UNITED STATES PATENT AND TRADEMARK OFFICE  
**CERTIFICATE OF CORRECTION**

PATENT NO. : 7,046,434 B1  
APPLICATION NO. : 10/020527  
DATED : May 16, 2006  
INVENTOR(S) : DiJaili et al.

Figure 2

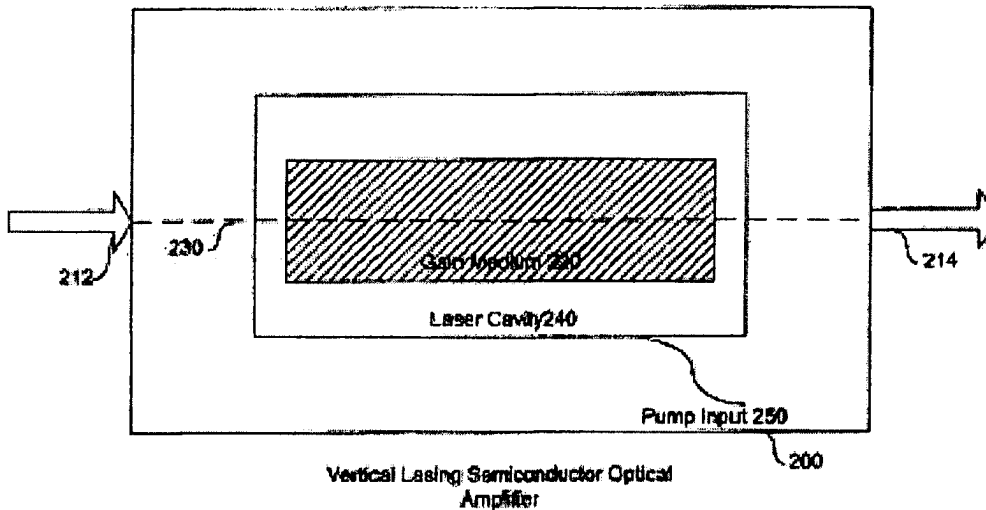
Sheet 2, change "Figure 2" to the figure depicted herein below, wherein the reference "201" has been removed.

Figure 4C

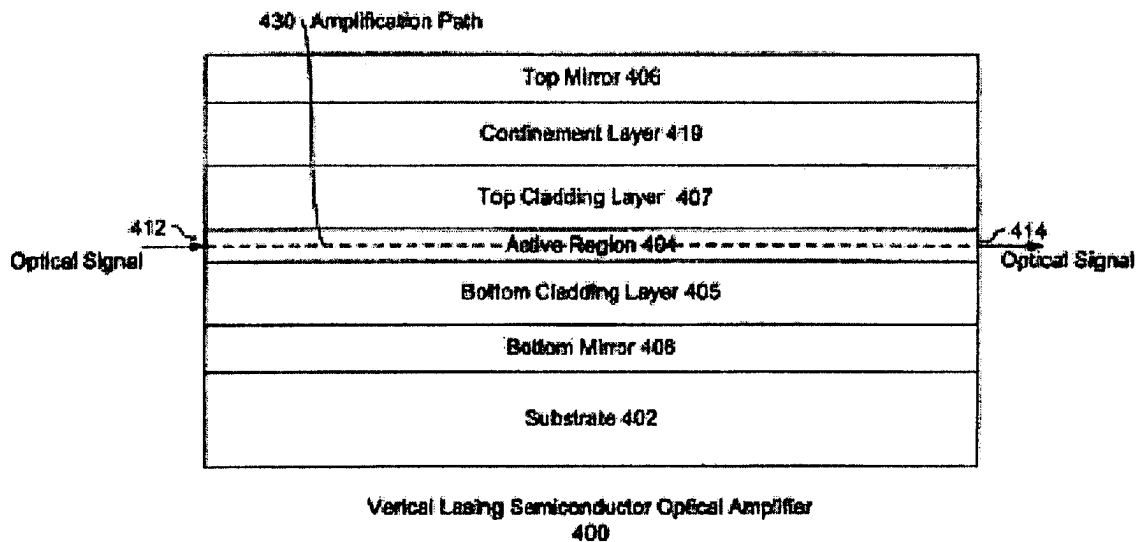
Sheet 6, change "Figure 4C" to the figure depicted herein below, wherein the Top Cladding Layer has been labeled --407--

Figure 7A

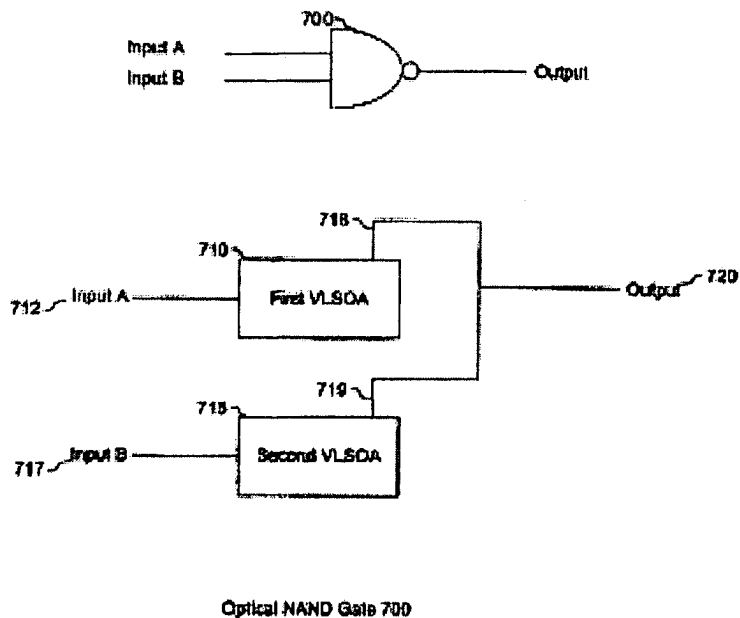
Sheet 11, change "Figure 7A" to the figure depicted herein below, wherein the NAND gate has been labeled --700--

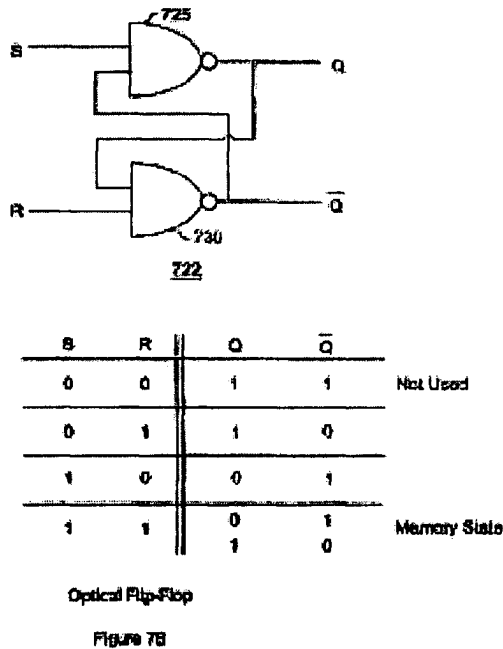
Sheet 12, change “Figure 7B” to the figure depicted herein below, wherein the 2<sup>nd</sup> and 3<sup>rd</sup> row of the outputs have been change to --1-- and --0--, and --0-- and --1--, respectively.

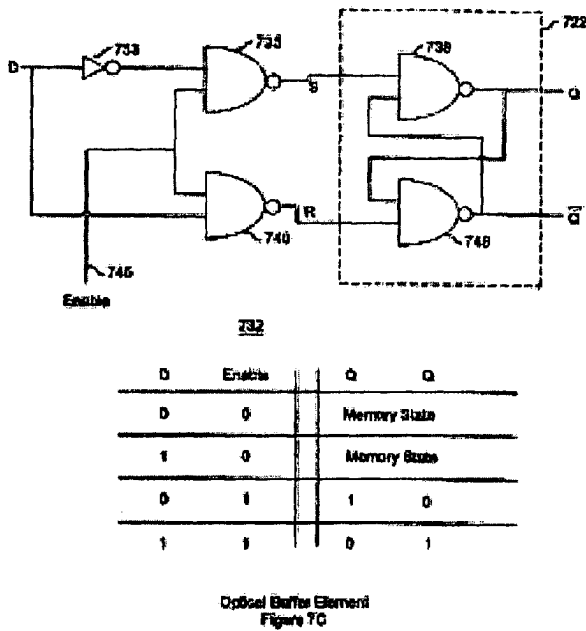
Sheet 13, change “Figure 7C” to the figure depicted herein below, wherein the 3<sup>rd</sup> and 4<sup>th</sup> row of the outputs have been change to --1-- and --0--, and --0-- and --1--, respectively.
